NEW IRON ENTRANCE GATE
331 ROYAL STREET
NEW ORLEANS, LOUISIANA

Permit No. 16-33859-VCGEN

Work approved:

A-1

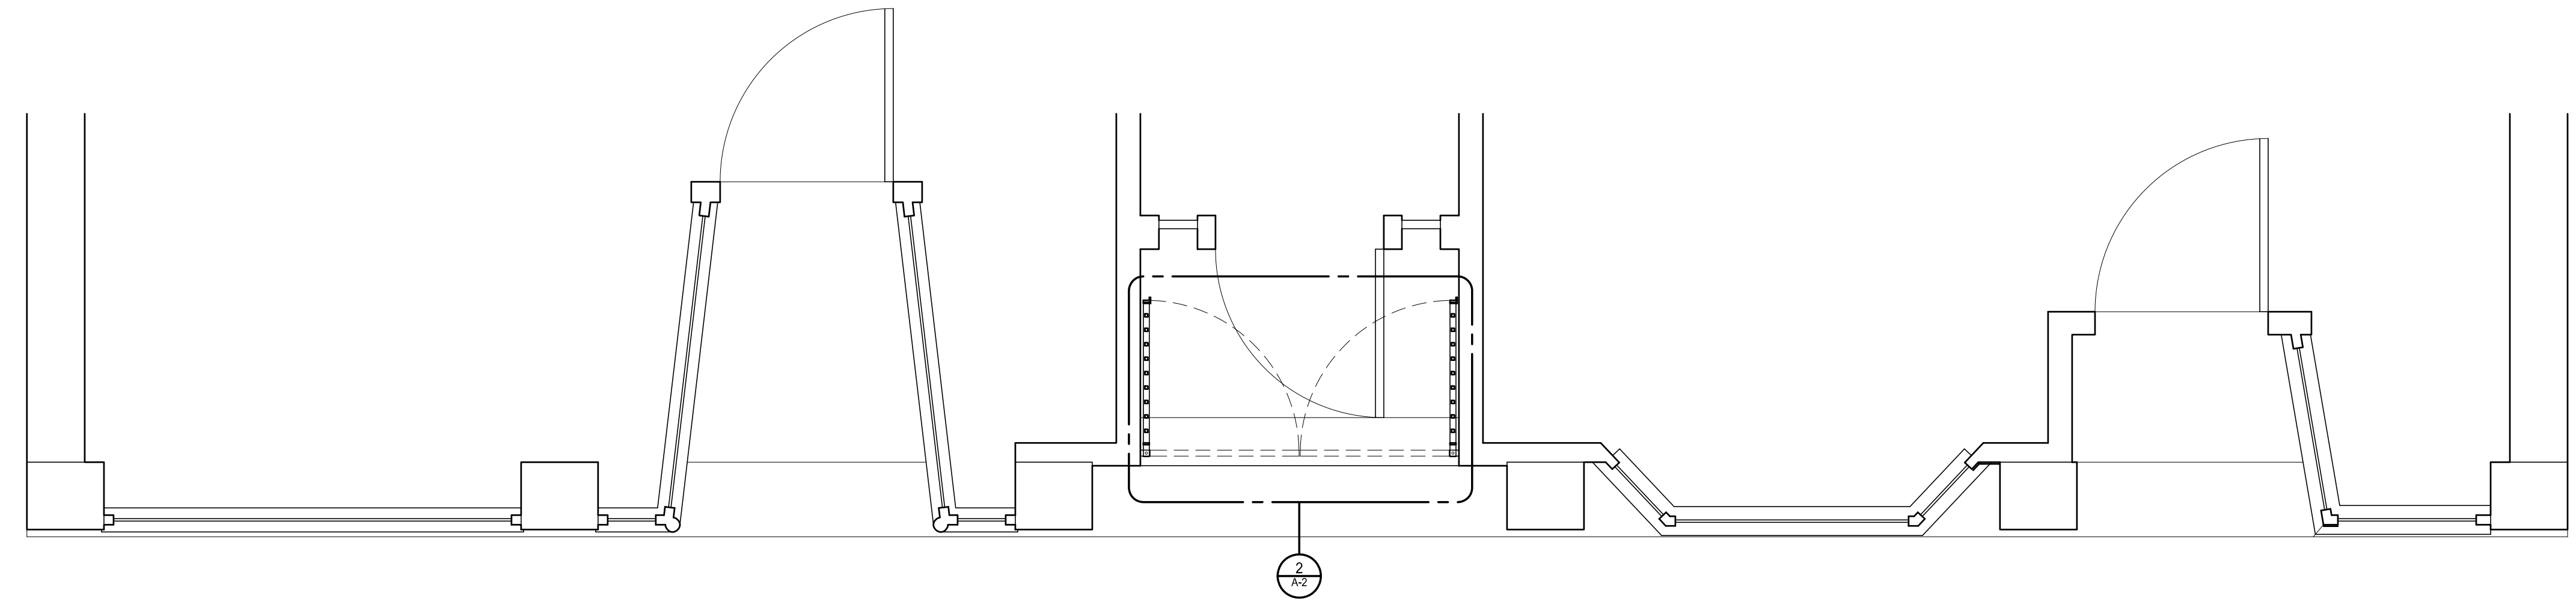
NOTE: Correct address is 431 Royal

To install new steel gates in the center alcove of the ground floor of the Royal St. elevation as per Architecture Committee approval of 05/08/18 and final materials stamped VCC approved 05/29/18
 Gate to be made with 5/8" square steel pickets with pyramidal cut tips
 Pickets to be punched through 3/8" x 1 -1/4" steel flat bars
 Pickets to be spaced 3" on center
 Gate to be painted black
